ADDENDUM NO. 2

SR 169 Widening Phase 1 Roadway Improvements
Witte Road SE to SE 240th Street
City Project T-39
TIB Project 8-1-205(005)-1

Date: February 12, 2019
To: All Plan and Specification Holders
From: Scott Soiseth, P.E.
Subject: SR 169 Widening Phase 1 Roadway Improvements
Date of Bid Opening: February 19, 2019

STANDARD PLAN B-10.70-00

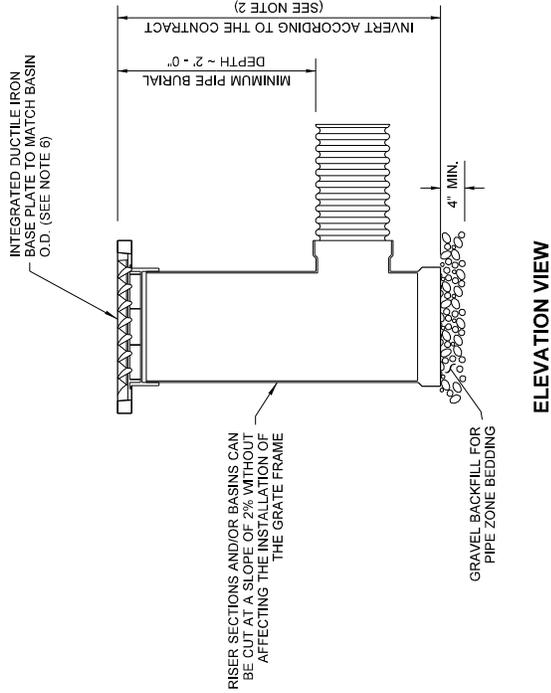
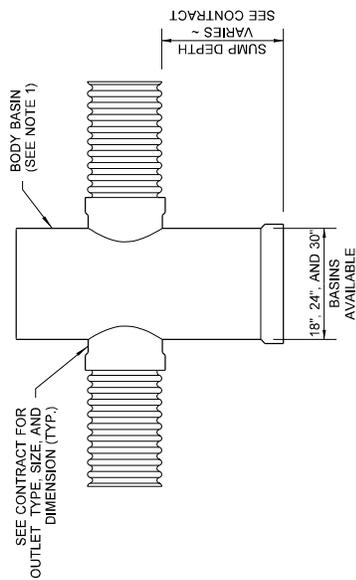
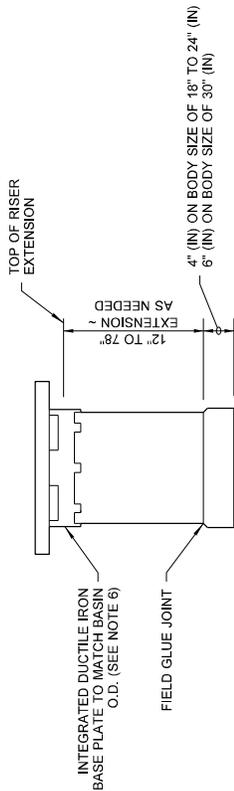
- 1) Replace Line 7 on Page SP-106 under Special Provision 7-04.2 with the following:
Storm Sewer Pipe, called for as PVC in the Plans, shall be either of the following:
- 2) Supplement Special Provision 7-05.2 with the following:
PVC catch basins shall meet the requirements of WSDOT Standard Plan B-10.70-00.
- 3) Replace Item 3 on Page SP-148 under Special Provision 8-20.1 with the following:
 3. Install illumination conduit, excavate luminaire foundations, and provide foundation casing. PSE Intolight will construct foundations, install luminaires and junction boxes, install conductors, and connect to existing electrical services upon completion of City contractors work.
- 4) Appendices
 - a. Appendix A – Add new WSDOT Standard Plan B-10.70-00 Catch Basin – PVC.
